**Meeting:** 4/21/2022  
**Applicant:** Travis Brooks Jonathan Miller Architecture & Design  
**Owner:** Simonne Wortham

**Location:** 1065 Scenic Dr. **Parcel ID** 121 D C 037  
**District:** Scenic Drive NC  
**Zoning:** RN-1 (Single-Family Residential Neighborhood)  
**Description:** Neoclassical, c.1931

Level II Construction of Addition or Outbuilding

## HZC Design Review Set April 04, 2022

1 ENLARGED SITE PLAN OVER SURVEY  
SCALE: 1" = 10'

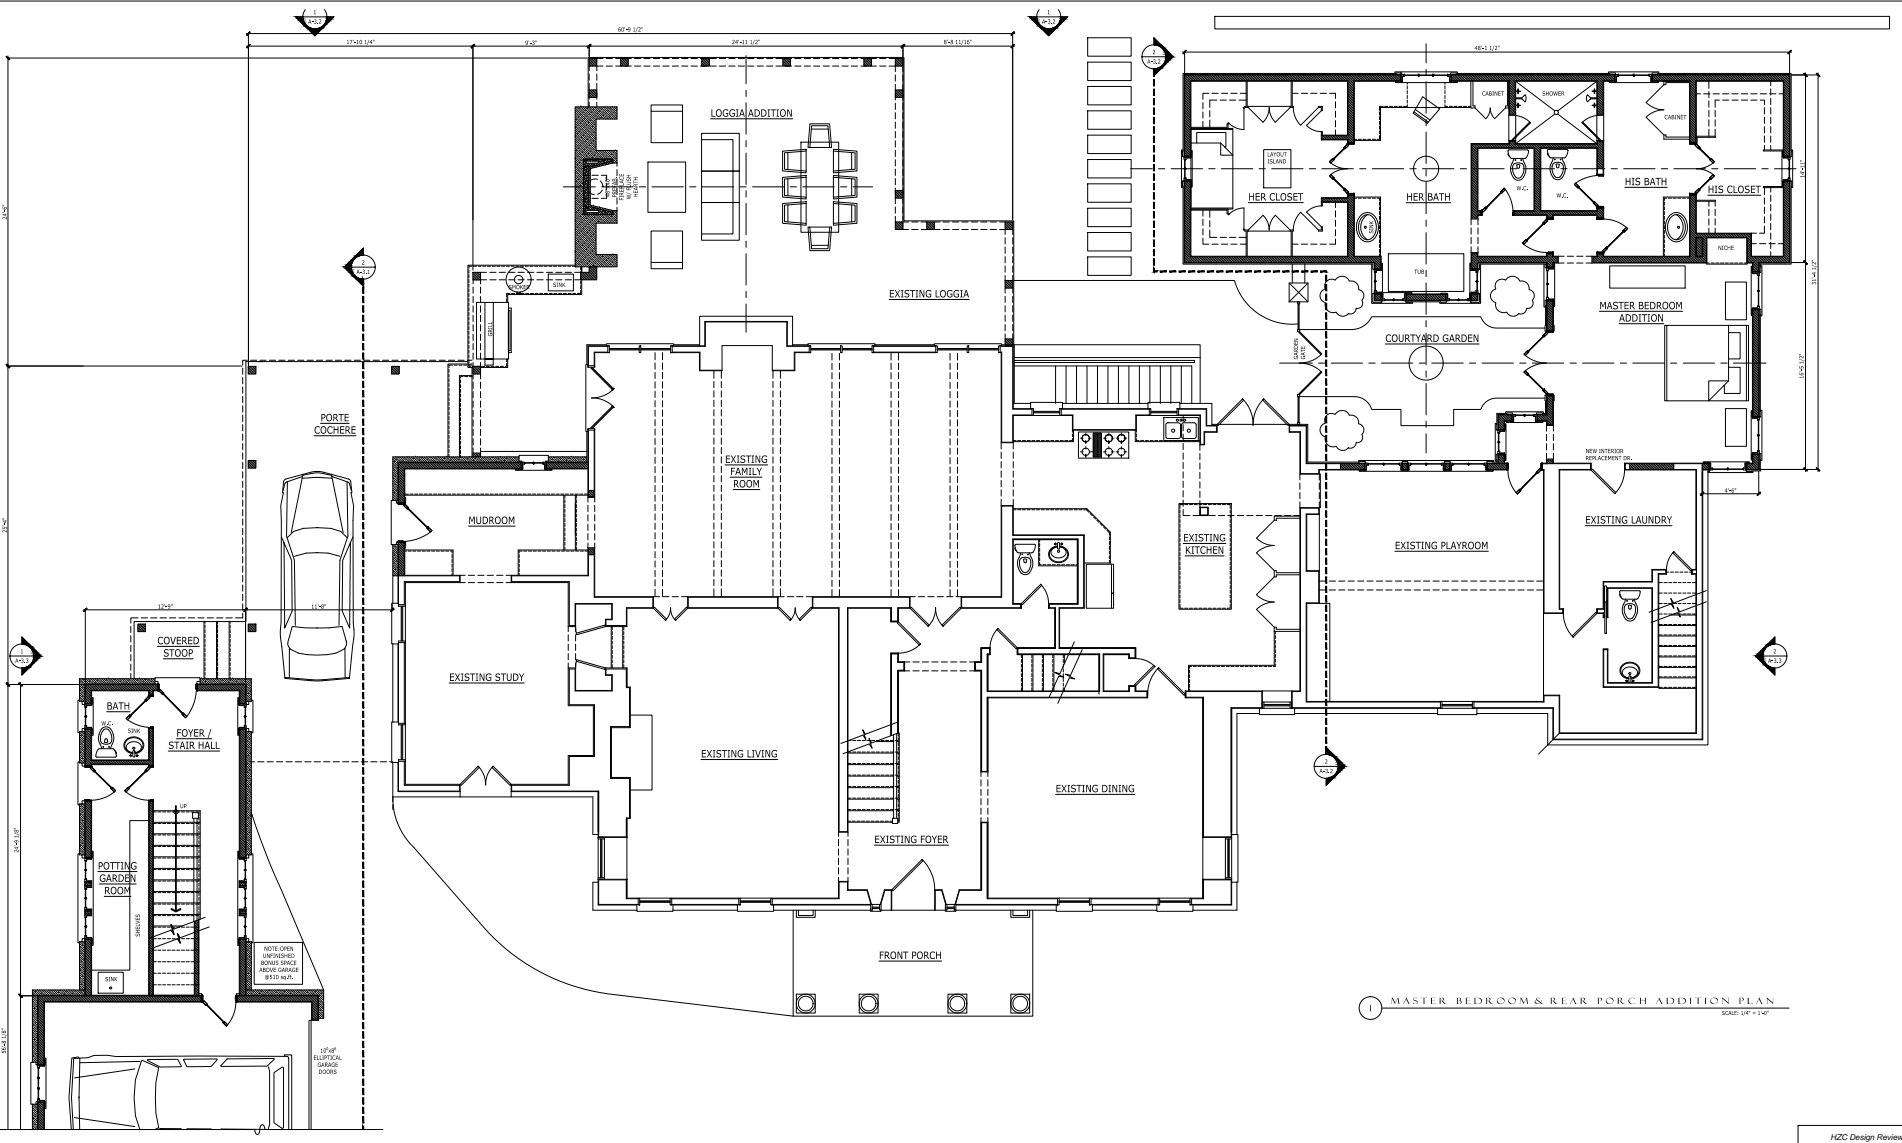
4. The proposed placement of the garage does not meet the design guidelines. Guidelines recommend that if additions are to be made to the side elevations of existing buildings, they "should be located at least five feet behind the front façade of the existing building." They also recommend that detached accessory buildings, including garages, "should be located at least fifteen feet to the rear of the front façade line." The applicant has cited constraints of site topography and the desired floor plan, motivating the front placement of the garage. If feasible, the garage should be recessed further to the rear property line to align more closely with the design guidelines.

Staff recommends approval of Certificate 2-B-22-HZ, subject to the garage's revised placement further towards the rear property line.
